**Report to the Future Melbourne (Planning) Committee**

**Planning Permit Application: TP-2016-1054  
6-10 Gardiner Street, North Melbourne**

4 September 2018

## DELEGATED PLANNING APPLICATION REPORT

Figure 2 – location of nearby solar panels. Source: NearMap 4 April 2018

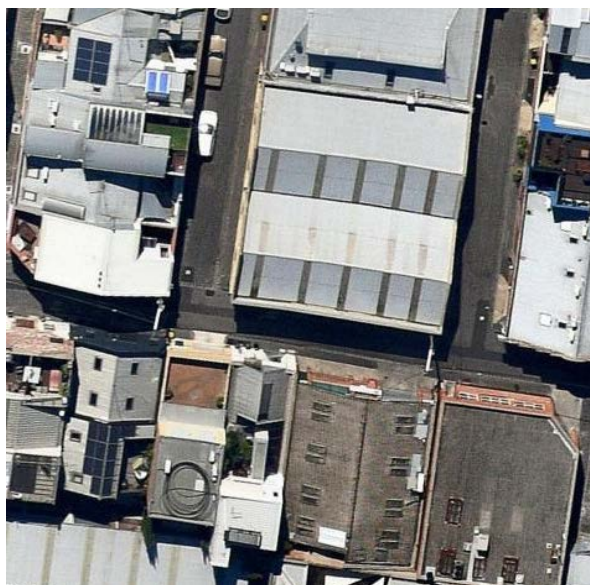
The overshadowing diagrams show that shadow impact to the buildings directly south of the development will fall primarily on the northern facades and the edge of the roof and terraces. It is considered that the impact is minimal and will not unreasonably impact upon any nearby solar panels (to the south) as shown on recent aerial photography

Impact upon the location of potential/future solar panels cannot be considered, however it is noted that the shadow cast to adjoining properties is within planning scheme requirements. This is not expected to unreasonably reduce the efficiency of any solar panel system or the viability of any future solar panel installation for surrounding properties.
